Western Regional Planning Panel (WRPP)

Dubbo Regional Council

2016WES006 – Dubbo - PP_2016_DUBBO_005_00
“Daisy Hill”

Date – 16 August, 2019

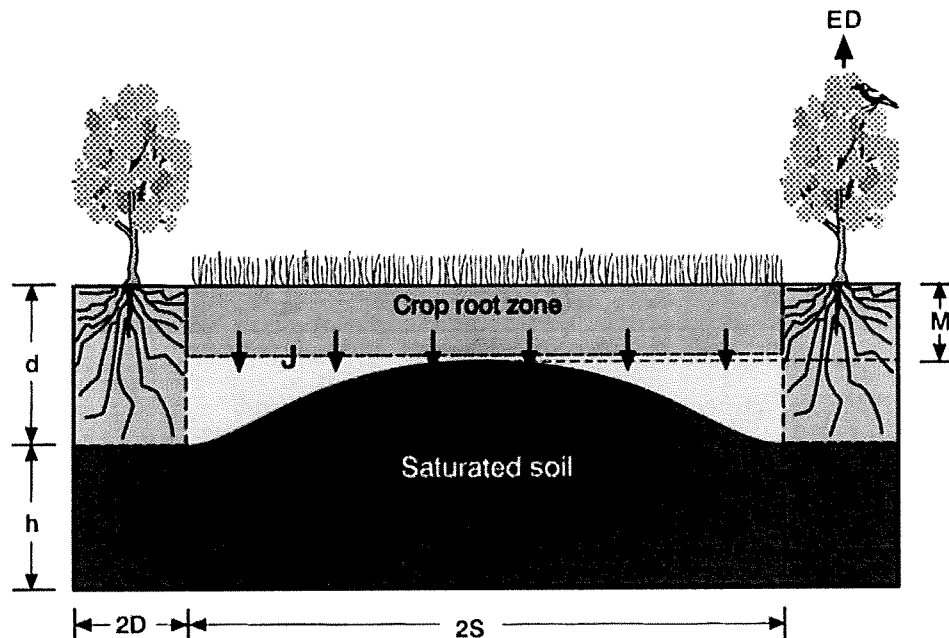
- The SSM review of Daisy Hill Groundwater and Salinity Modelling found;
 - EnviroWest propose the concept that vegetation planted along the subdivisions roads will intercept groundwater, both at depths greater than 6m and uniformly. SSM cite research by Stirzaker which disproves both concepts. Tree zones will be able to intercept groundwater only shallower than 6m, and the zones between plantings (i.e. the residential lots) will experience significantly shallower groundwater than that once this state has been achieved as shown by the following diagram (taken from the SSM review).

- EnviroWest propose that tree plantings alone will lower the water table sufficiently to minimise shallow groundwater within the estate. Vegetation planting along roadways will likely lower groundwater along the planted corridors (roadways) but, as shown above will not decrease groundwater levels at distance (i.e. on the residential lots). Furthermore in order for groundwater to reach levels at which tree plantings will impact the groundwater level that groundwater must rise to <6m. In order to achieve

- this, significant lateral pressure will be driving groundwater off site towards the vulnerable existing developments of Troy Gully and Eastridge.
- EnviroWest have used an appropriate vertical modelling but appear not to have modelled horizontal groundwater flow.

Figure 1. SSM interpretation of conceptual model used by Envirowest Consulting (2017b, 2018) for groundwater of proposed Daisy Hill Estate.

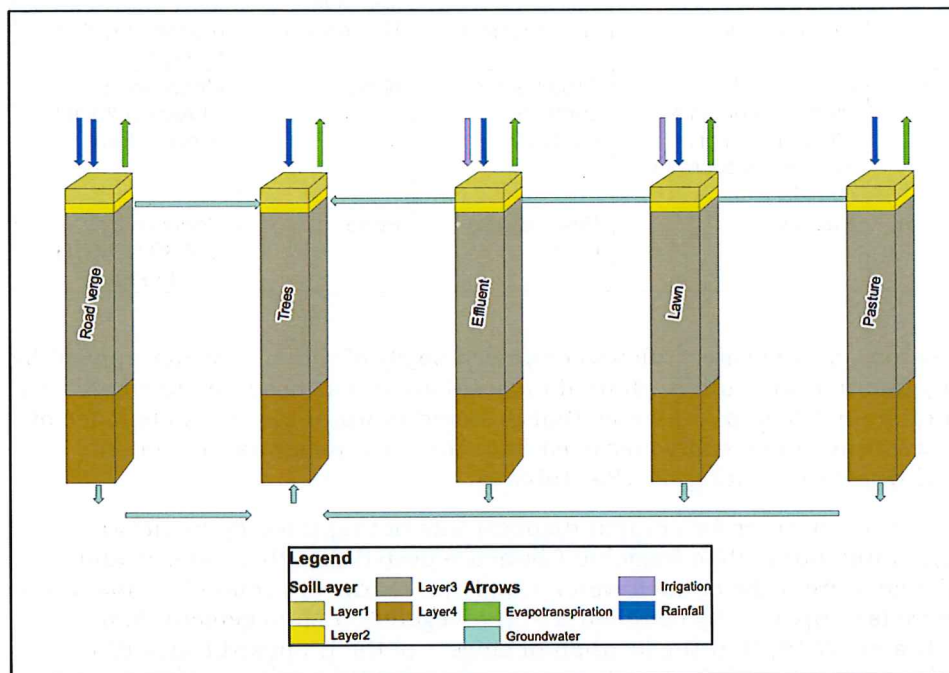
The Soilwater (2018) and EMM (2018) reviews indicate that the conceptual model of a number of soil domains represented by 1-dimensional water flow models and linked by lateral flow (Figure 1) is an appropriate way to characterise groundwater in the proposed Daisy Hill Estate. We agree that this conceptual model is an appropriate one, but not the way it has been applied.

This is because we have reservations about the magnitude of the lateral flow between these domains. These reservations will be outlined separately for the shallow (<70 cm) and deep (>1 m) layers.

Slope (from DCC DE¹/₂ and Proposed Layout)

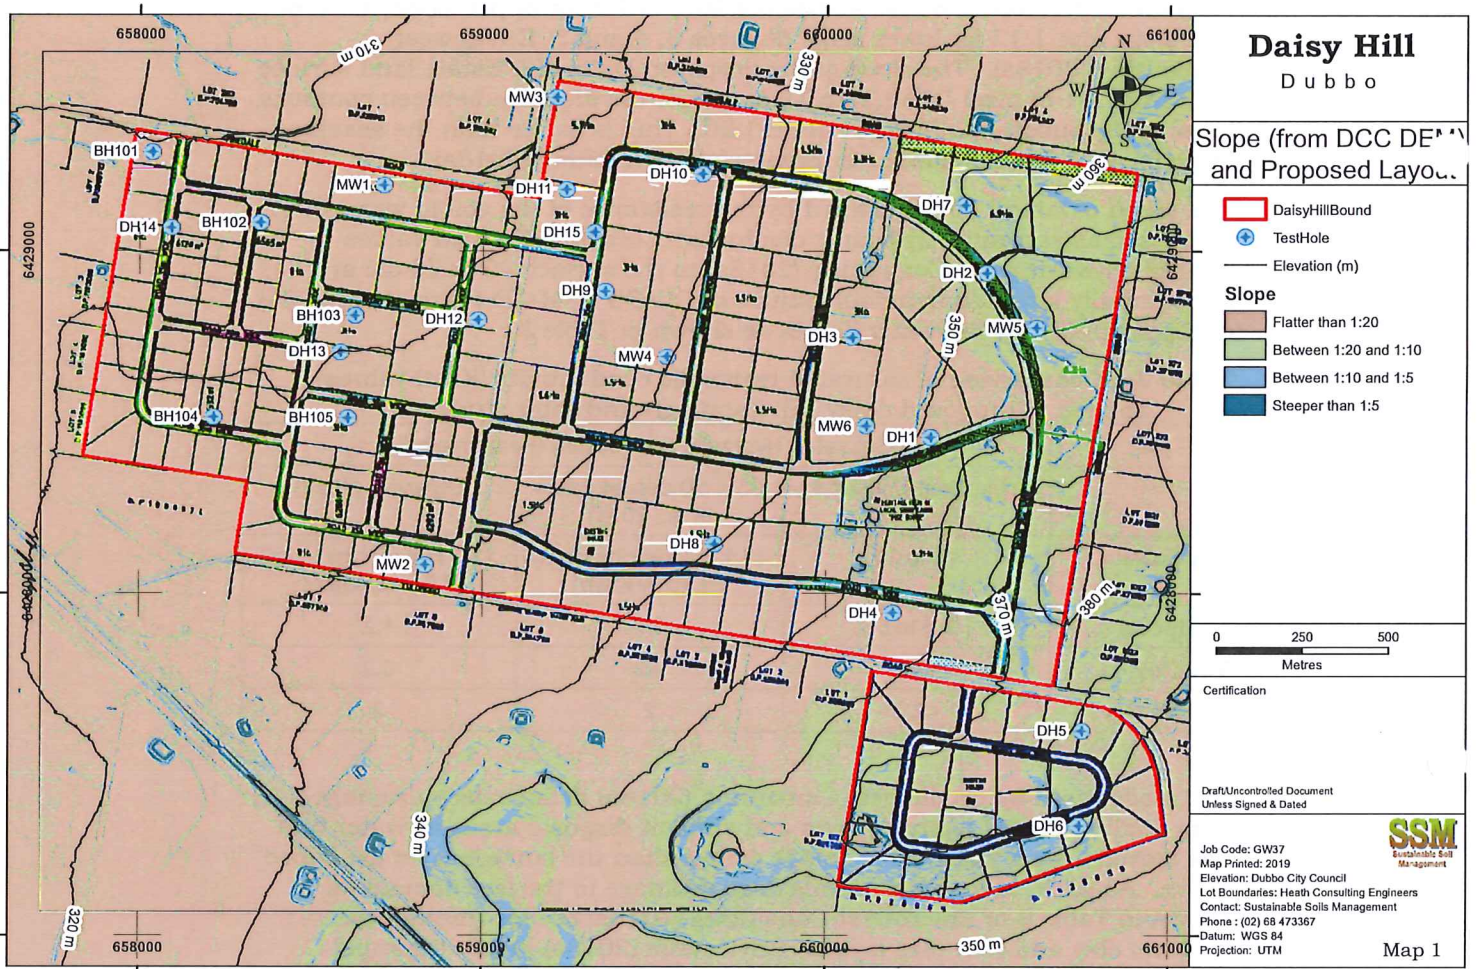
Lateral groundwater flow between domains is driven by fall across the land, and is assumed to occur with no head loss or regard to water content of the formation. The assumed fall across the land is 1:3 for upper slope, 1:12 for mid slope and 1:12 for lower slope (Figures 3, 4 and 5, Envirowest Consulting, 2018a). The slope of the proposed Daisy Hill Estate land surface both from a 1 m pixel DEM (Map 1), and from the distance between contours is generally substantially flatter than 1:20. This is flatter than the assumed slope for all 3 Lot schematics in Envirowest Consulting (2018a).

The speed of lateral flow is limited by the resistance of the soil to water flow, expressed as saturated hydraulic conductivity (Ksat). The Ksat values applied by Envirowest Consulting (2018a) to the surface 20 to 70 cm are substantially larger than default values in CLASS U3M-1D (Vaze *et al.*, 2004) or those applied by Soilwater (2018) as shown in Table 3.

Figure 2. Schematic diagram of water uptake by trees when groundwater level is below tree rootzone (from Stirzaker *et al.*, 2003).

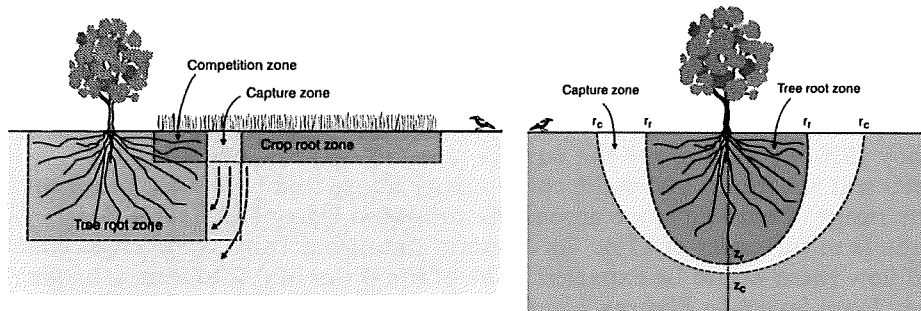
For soil deeper than the pasture rootzone, Envirowest Consulting (2017a, 2017b and 2018a) propose that water will flow along gravel and sand lenses intercepted in some test holes. This mode has been evaluated by Stirzaker *et al.*, (2003) who examined 2 scenarios relevant to the proposed Daisy Hill Estate. The first scenario is when the water table is below the depth of tree root system. In this case, Stirzaker *et al.*, (2003) found that trees access little water by lateral flow because the capture zone (Figure 2) is dry, consequently transmits little water.

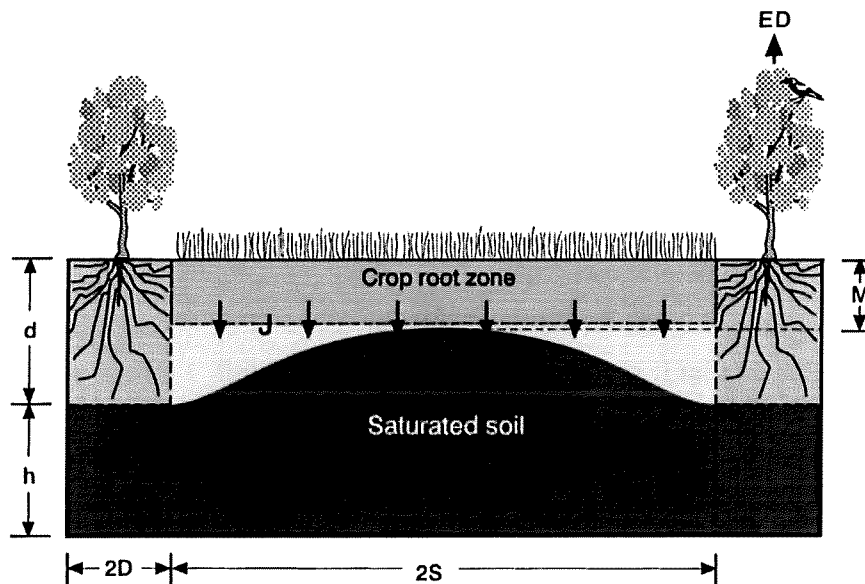
These estimates indicate that the proposed tree plantings could lower the water table sufficiently to minimise the area of shallow groundwater within the proposed Daisy Hill Estate. However, there will be some deep drainage beneath the land as a shallow water table is required to provide the force to move water towards the trees. Furthermore Benyon *et al.*, (2006) in a review of data from 21 Australian sites found that trees could lower groundwater levels to around 6 m. As a result, trees will not take up significant groundwater in areas represented by Figures 3 to 5 and Envirowest Consulting (2018a) until groundwater levels rise from the current 12 and 14 m to shallower than 6 m.
